DRAWING NUMBER:
5006CFP

FLOOR PLAN - 12BC-125-SS

BAPTISTA'S

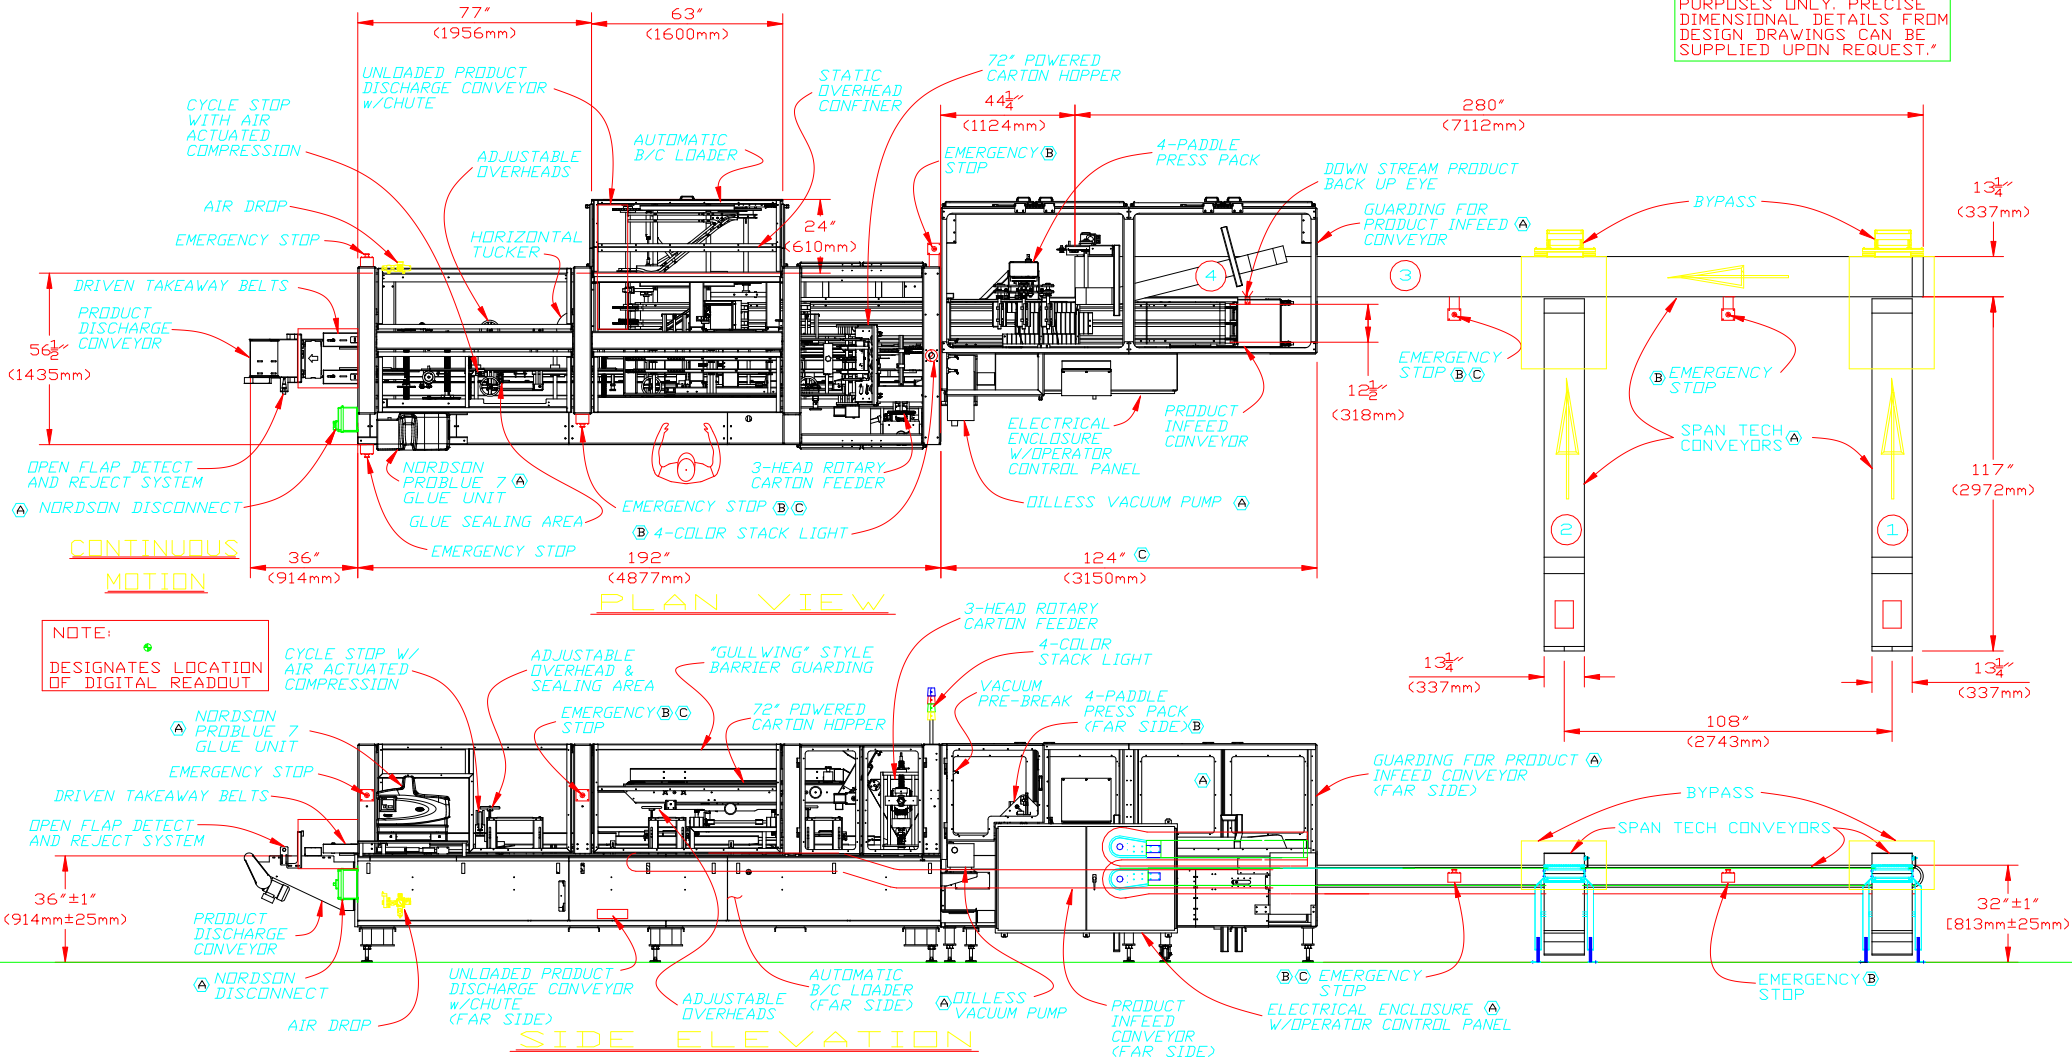
7/02/08	(C)	RELOCATE EMERGENCY STOP LOCATION; UPDATE MACHINE LAYOUT FOOTPRINT	DD	JKY
5/16/08	(B)	SHOW TWO (2) EMERGENCY STOP LOCATIONS; RELOCATE ONE EMERGENCY STOP; REMOVE ADDITIONAL ELECTRICAL ENCLOSURE FROM FLOOR PLAN	DD	JKY
3/06/08	(A)	ADD GUARDING AROUND INFEED CONVEYOR; LABEL SPAN TECH CONVEYORS; ADD SECOND ELECTRICAL ENCLOSURE; CHANGE ORIENTATION OF VACUUM PUMP; AND CHANGE LOCATION OF NORDSON GLUE UNIT AND NORDSON DISCONNECT	CAW	JKY
DATE	SYM	NOTES	AUTH	BY
